# 2020/1414/P 1-6 Centric Close

<b>Delegated Report (Member's Briefing)</b>		<b>Analysis sheet</b> N/A	<b>Expiry Date:</b>	17/04/2020	
<b>Officer</b>		<b>Application Number(s)</b>			
Patrick Marfleet		2020/1414/P			
<b>Application Address</b>		<b>Drawing Numbers</b>			
1-6 Centric Close London NW1 7EP		Please refer to draft decision notice			
<b>PO 3/4</b>	<b>Area Team Signature</b>	<b>C&amp;UD</b>	<b>Authorised Officer Signature</b>		
<b>Proposal(s)</b>					
Installation of two additional air conditioning units to rear of site as non-material amendments to permission reference 2016/6891/P dated 29/09/2017 (Demolition of existing buildings (Class B1(c) & B8) and the erection of a part 4, part 5, part 6 and part 7 storey building comprising 1,219 sqm of commercial floorspace (Use Class B1) at basement and ground floor levels and 76 residential units (28 x 1-bed; 35 x 2-bed and 13 x 3-bed) (Class C3) including disabled car parking, landscaped courtyard and communal amenity areas).

### Grant of Non-Material Amendments to planning permission

### 4. Proposed ground floor plan

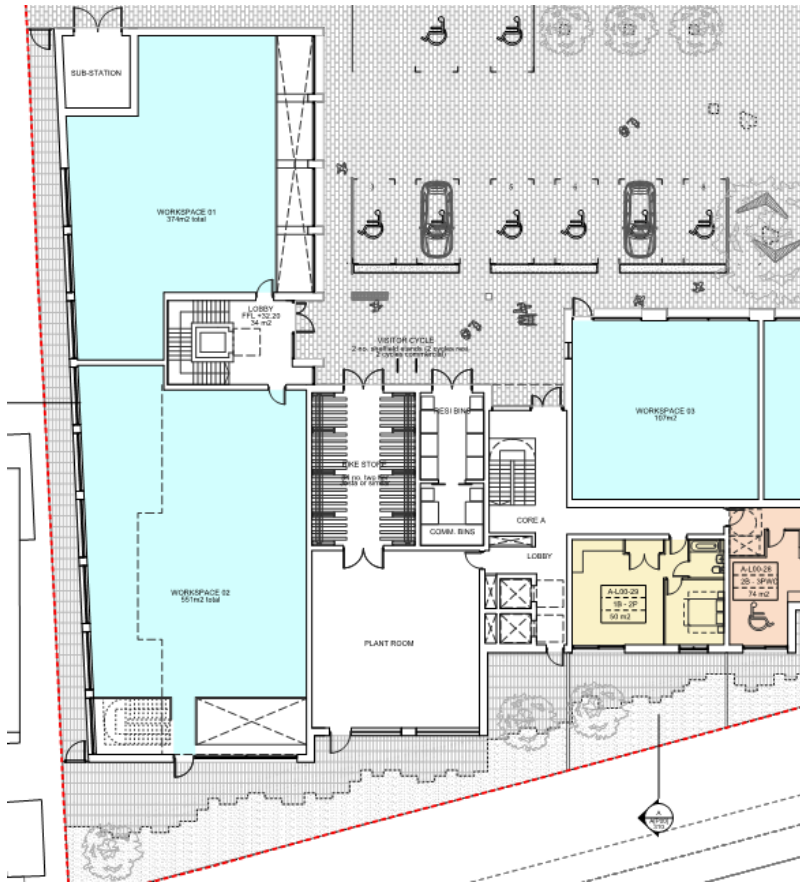
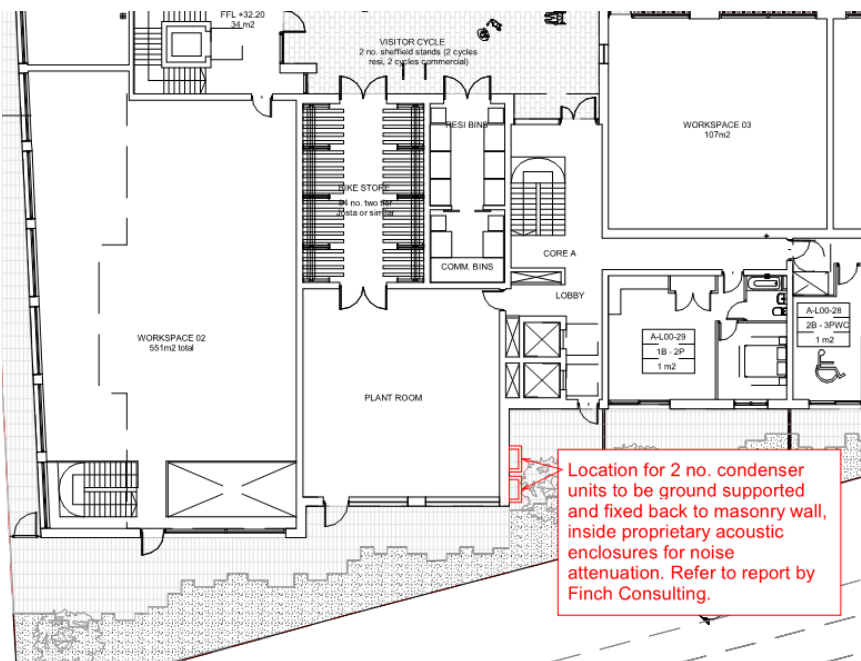
1.1 The current application seeks to install two additional air conditioning condenser units at the site, as non-material amendments to the development approved under permission reference 2016/6891/P. The two units would be fixed to the west (rear) elevation of the approved building at ground floor level and would be housed within acoustic attenuation enclosures. The proposed units would provide cooling for the approved commercial units at the site.

2.2.2 The proposed air conditioning units would be situated in a discreet location to the rear of the approved development and their overall size and scale would ensure no harm is caused to the architectural integrity and design of the building. Furthermore, the units would be located to the rear of the site and ground floor level and would have very limited visibility from the public realm, particularly given the existing railway line that bounds the site to the rear. As such, the proposals are not considered to cause harm to the appearance of the surrounding area.

2.3.2 Condition 9 of the original planning permission required noise levels from the approved plant/equipment at any sensitive façade shall be at least 10dB(A) below the LA90, expressed in dB(A). The applicant has submitted an updated acoustic report which demonstrates that the proposed AC units can achieve the requirements of Condition 9 of at least 10dB below the background noise levels at the nearest sensitive noise receptor. The report recommends that this is achieved through the use of acoustic enclosures. As such, the proposed air conditioning units would comply with the relevant noise conditions of the original permission and would not cause harm to the amenity of neighbouring residents in terms of noise and disruption. Further, the size and location of the propose units would ensure no harm is caused to neighbouring residents in terms of loss of light or outlook.

2.4.1 Officers note the concerns that have be raised from the PHCAAC regarding the absence of any information to demonstrate that the current amendments have been informed by the London Plan 'cooling hierarchy'. The cooling hierarchy, as referenced in Policy CC2 of the Local Plan, states that active cooling (air conditioning) will only be permitted where dynamic thermal modelling demonstrates there is a clear need for it after all of the preferred measures are incorporated in line with the cooling hierarchy.

2.4.2 The original approval at 1-6 Centric Close (2016/6891/P) included the submission of an Energy Statement, Sustainability Assessment, and an Overheating Analysis. These documents confirmed that no mechanical cooling was proposed for the residential flats within the development but that mechanical cooling for the commercial units at ground floor was assumed. Section 6.2 of the approved Energy Statement makes this assumption and factors this requirement in to the calculations for the energy demand from the non-residential units on the building. As such, the output from the energy modelling accounts for mechanical cooling, with a quoted energy consumption of 2.72kWh/m<sup>2</sup> related to cooling. The assumed mechanical cooling (AC) is also referenced in The Cooling Hierarchy, referred to within the Addendum of the Energy Statement and addressed in the separately submitted Overheating Analysis report.

2.4.3 Given the above, it is clear that mechanical cooling had always been assumed for the ground floor commercial units, and this had been factored in to the energy demand calculations as well as a cooling hierarchy, in accordance with the Council's policies. However, no provision had been made in the original design for this system. This Non-Material Amendment application therefore seeks to provide details of the size, quantity and location of the proposed AC units to satisfy the need for the cooling of the commercial units.
